Access Compliance Report

Public Rights-of-Way

(Curb Ramps)

Intersection ID: 49184	Main Street: ST_GERMAINE_LN	Cross Street: ST_STEPHEN_LN	Location: NW
ADA ID: 81CA44E52018	Ramp Type: Perp	Initial Pass/Fail: Fail	Overall Compliance: No Severity Score: 13.75

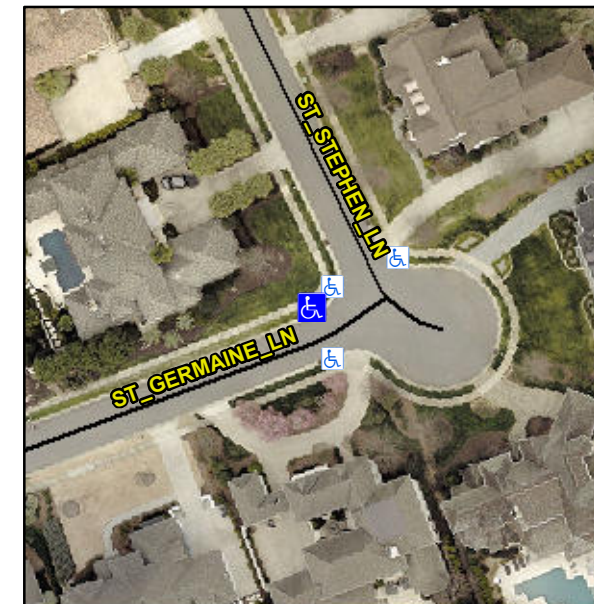
Not Found, R304.2.2

Compliance	Description	Data	Compliance	Description	Data
N/A	Ramp Length (in)	48.5	No	Ramp Slope (%)	10.7
Yes	Ramp Width (in)	48.0	Yes	Ramp XSlope (%)	2.7
N/A	Flare Type LT	N/A	N/A	Flare Type RT	N/A
N/A	Flare Slope LT (%)	N/A	N/A	Flare Slope RT (%)	N/A
N/A	Flare Traversable LT?	N/A	N/A	Flare Traversable RT?	N/A
N/A	Landing Length (in)	N/A	N/A	DWS Provided?	N/A
N/A	Landing Width (in)	N/A	N/A	DWS Contrast?	N/A
N/A	Landing Slope (%)	N/A	N/A	DWS Length (in)	N/A
N/A	Landing X Slope (%)	N/A	N/A	DWS Full Width?	N/A
N/A	Landing Curb? (Y/N)	N/A	N/A	DWS Offset (in)	N/A
N/A	Shared Landing?	N/A			
N/A	Gutter Ponding?	N/A	N/A	Gutter Slope (%)	N/A
N/A	Gutter Lip Ht (in)	N/A	N/A	Gutter X Slope (%)	N/A
N/A	Painted X Walk1?	No	N/A	Painted X Walk2?	N/A
	X Walk 1 Direction	To S		X Walk 2 Direction	N/A
N/A	X Walk 1 Width (in)	N/A	N/A	X Walk 2 Width (in)	N/A
	X Walk 1 Slope (%)	0.8		X Walk 2 Slope (%)	N/A
	X Walk 1 X Slope (%)	4.2		X Walk 2 X Slope (%)	N/A

Remove & Replace Entire Ramp.
